Duke Energy Carolina, LLC (Duke Energy)  
Catawba Nuclear Station, Units 1 and 2  
Docket Numbers 50-413 and 50-414  
Renewed License Numbers NPF-35 and NPF-52

**Subject:** Third Six-Month Status Report in Response to March 12, 2012 Commission Order Modifying Licenses With Regard to Requirements for Mitigation Strategies for Beyond-Design-Basis External Events (Order Number EA-12-049)

**THIRD SIX MONTH STATUS REPORT (ORDER EA-12-049)**

**CATAWBA NUCLEAR STATION (CNS), UNITS 1 AND 2**

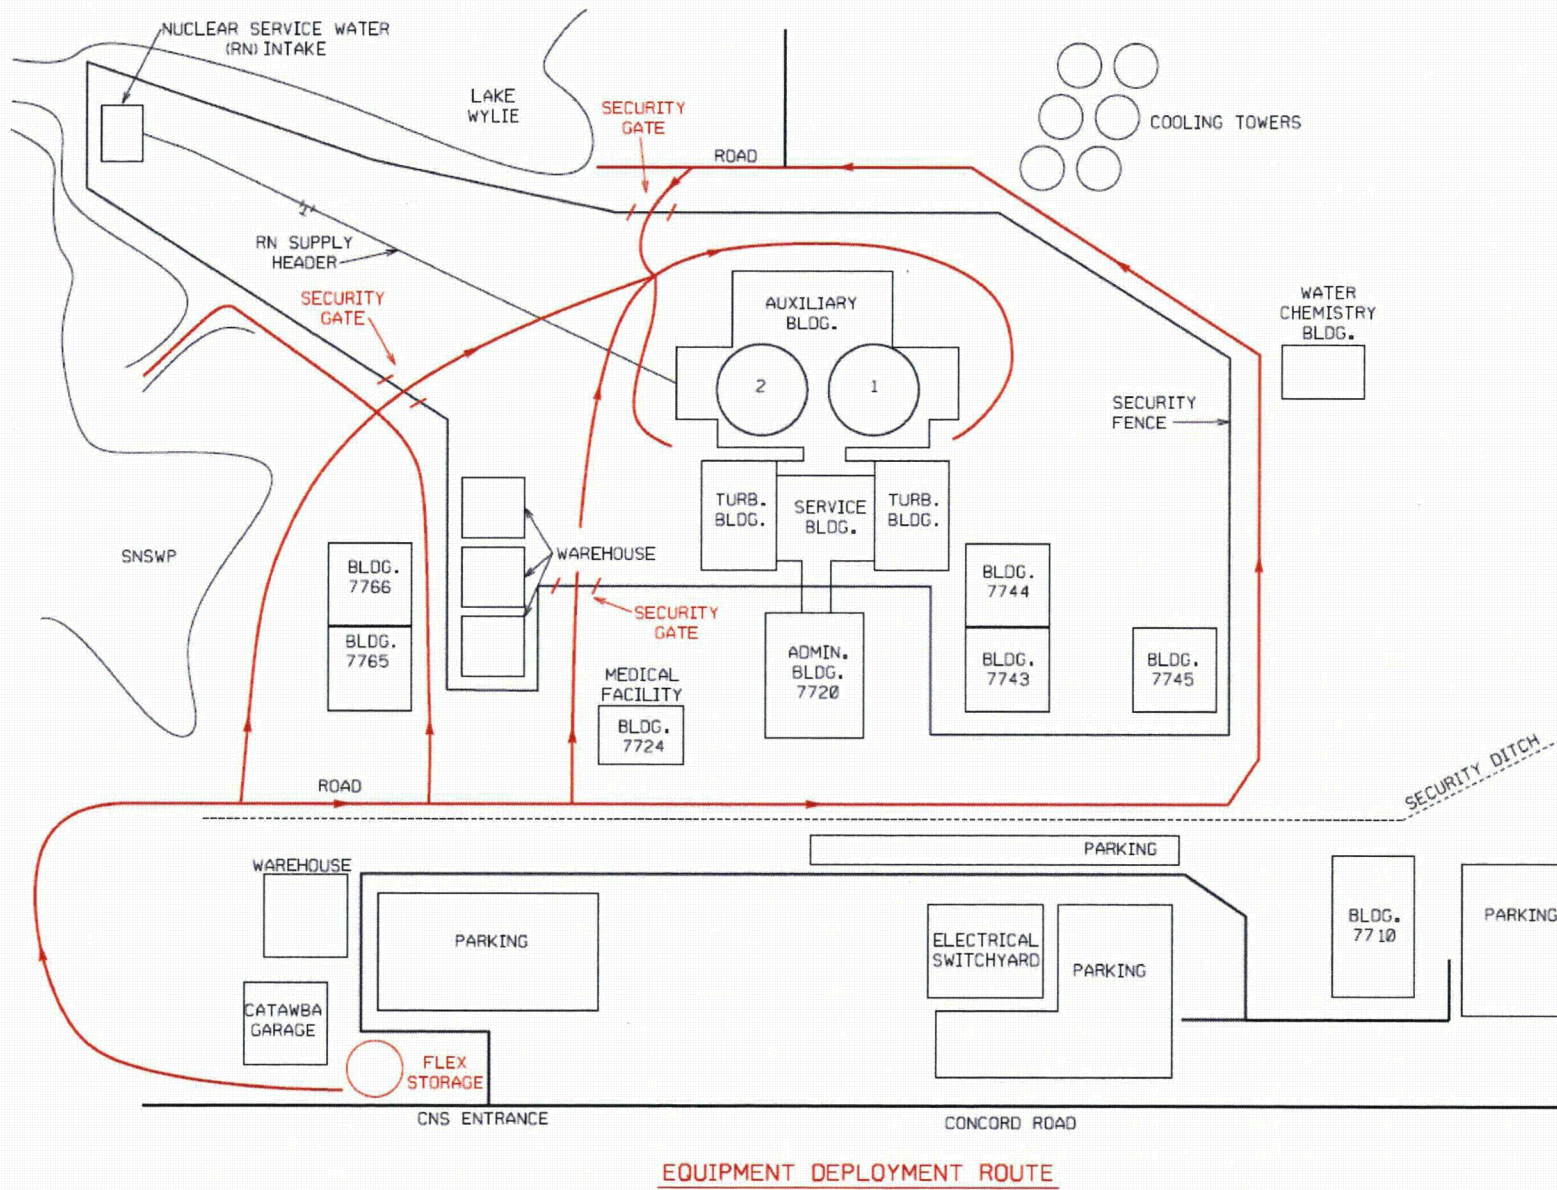
- 4) Change: A single hardened FLEX storage building will be utilized. The building will be located West of the Catawba garage.

Documentation: Open Item 27. Revised sketches for Equipment Deployment Route – Page 19 of this report, Portable Pump Supply to Essential Service Water Header / Storage Facility Locations – Page 20 of this report, and Portable Pump Supply to S/G's – Page 21 of this report.

PORTABLE PUMP SUPPLY TO ESSENTIAL SERVICE WATER HEADER / STORAGE FACILITY LOCATION

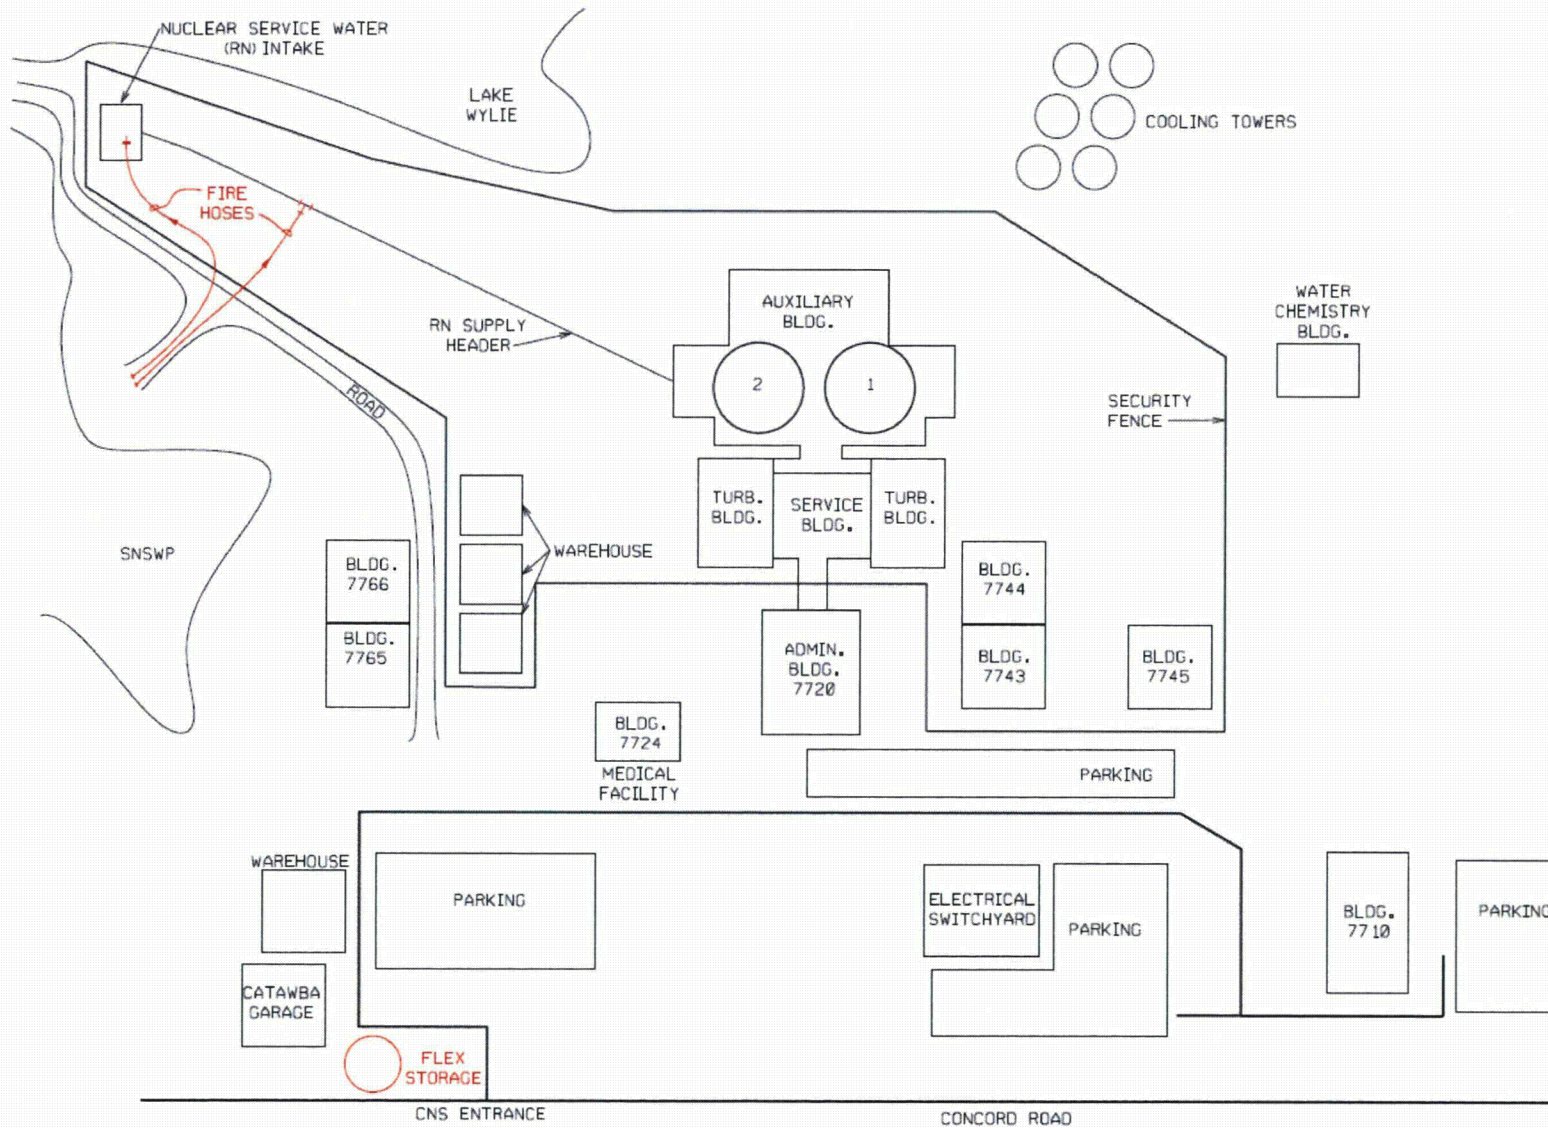
- 6) Change: The OIP discussed having a FLEX storage building located near the Standby Nuclear Service Water Pond (SNSWP) and the need to move equipment stored in this building to higher ground during a flood event. This will no longer be necessary since a single FLEX storage building is being constructed in a location that is well above any postulated flood levels.
